**Final
Environmental Impact Statement
and 4(f)/6(f) Evaluation
BART Warm Springs Extension**

VOLUME 2: RESPONSE TO PUBLIC COMMENTS

**BART Warm Springs Extension,
Fremont, California**

Volume 2: Response to Public Comments

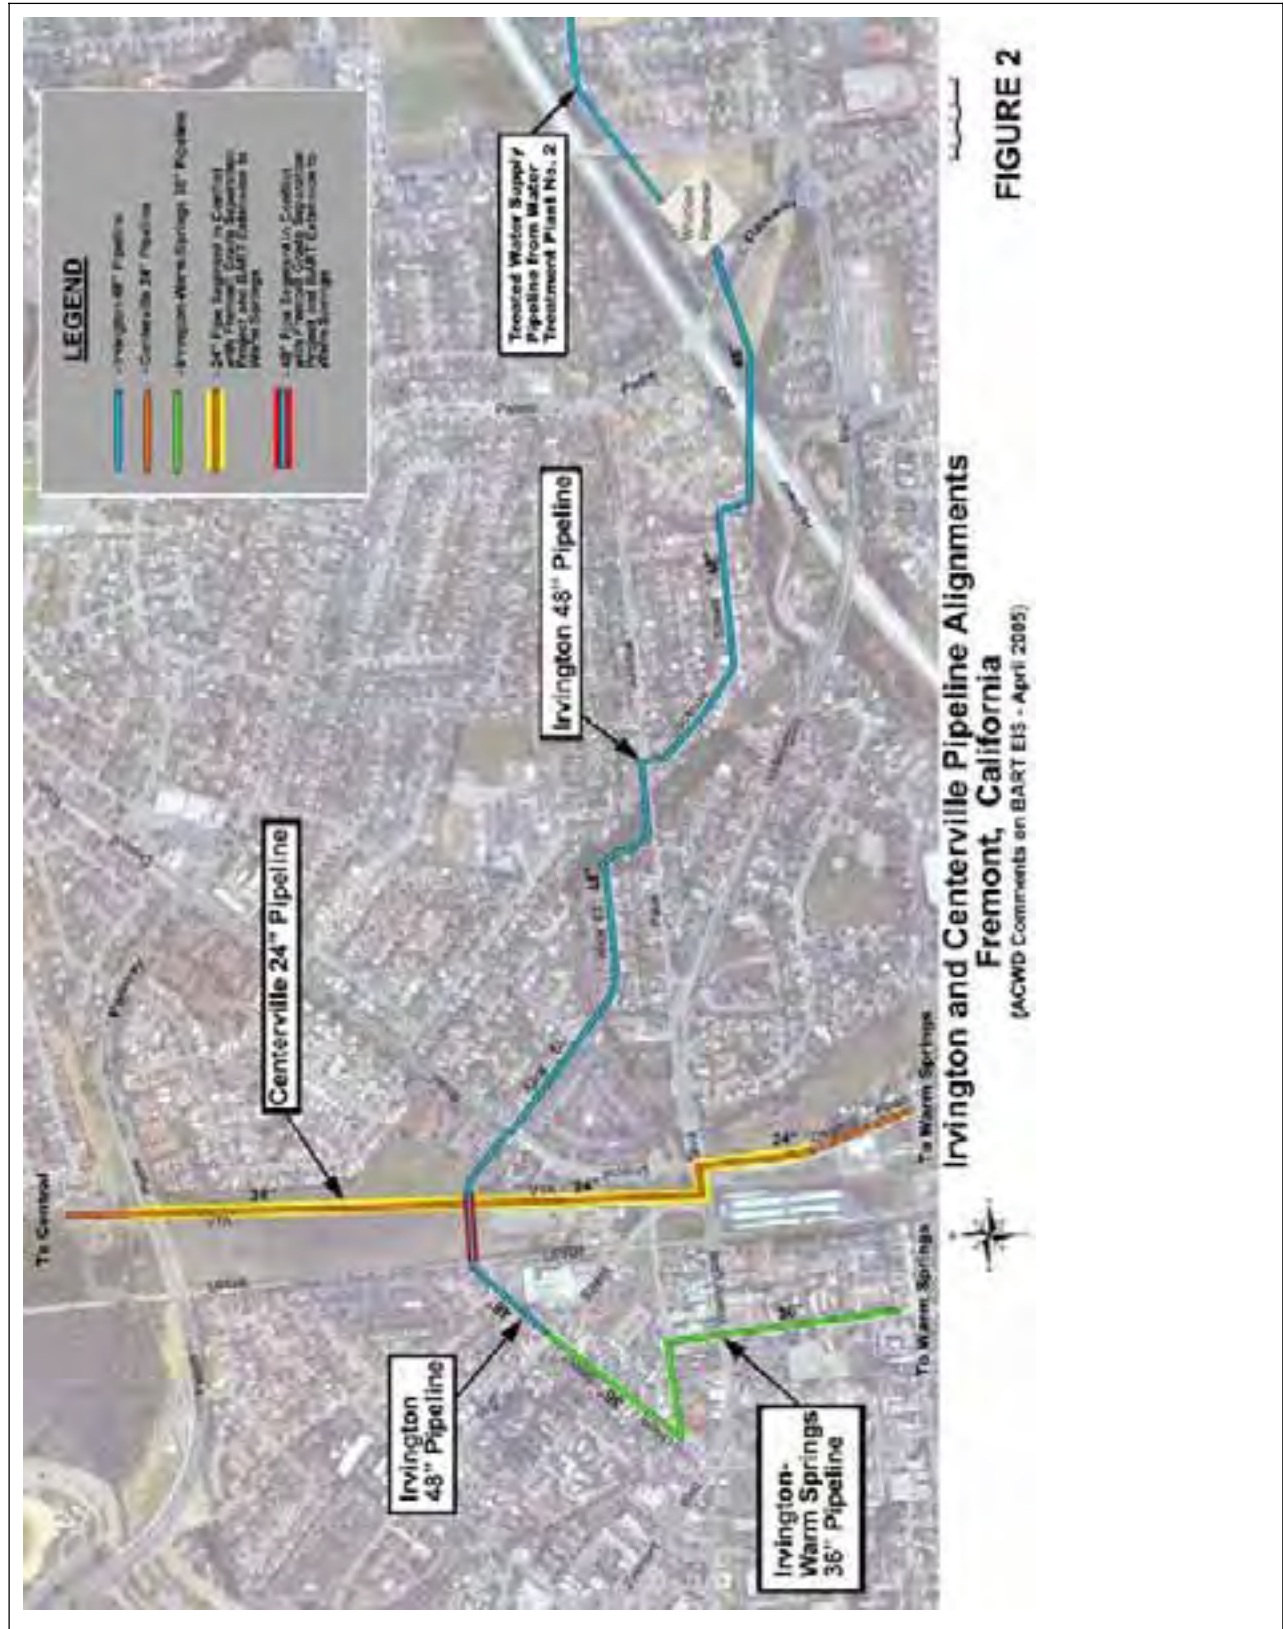
Figure 2-5d indicates that the proposed BART subway beneath Lake Elizabeth and the park will be at least 23 feet below ground surface to the track. The total depth of the subway, the depth and design of the proposed dewatering system, and the estimated quantity of extracted water needs to be documented in the DSEIR in order to assess the potential impact of the dewatering system on groundwater supplies. As indicated in the DSEIR, the depth to water in the Lake Elizabeth area can be as high as 8 feet below ground surface, so the potential impact of a dewatering system on ACWD's groundwater supplies could be very significant. Although the water extracted during construction of the subway appears to be exempt from the Replenishment Assessment fee, mitigation measures should be proposed to eliminate or minimize the impact of the project on the local drinking water supply.
